Boss Radio (AM/FM/CD/DVD) Installation

Bulletin Type:	TSB	Publication Date:	June 2022
Bulletin #(s):	22-045	Make(s):	Jayco & Entegra Coach
Job Code(s):	9803574	Model(s):	Ethos, Launch Swift, Terrain
Flat Rate(s):	.10 Inspection only .30 Remove Radio bezel screws	Model Year(s):	2021-2022

Incident:	Boss Radio CD/DVD ejection function issue
Affected Units:	Certain 2021-2022 Jayco Swift & Terrain; Certain 2021 -2022 Entegra Coach Ethos & Launch
Parts Kit:	Parts Kit #: N/A
	Parts Kit Contents: N/A
Misc. Tools & Supplies:	- Screw gun with square head bit
Parts Return Information:	N/A

Fig 4

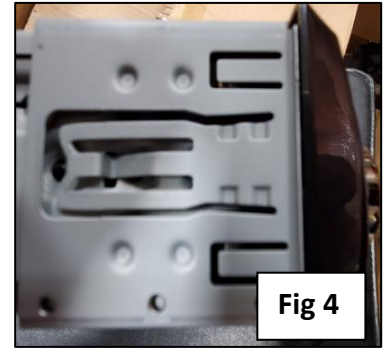
5. Verify the radio locks into the metal radio mounting metal radio bezel. If not, remove radio and bend tabs inward located on each side.
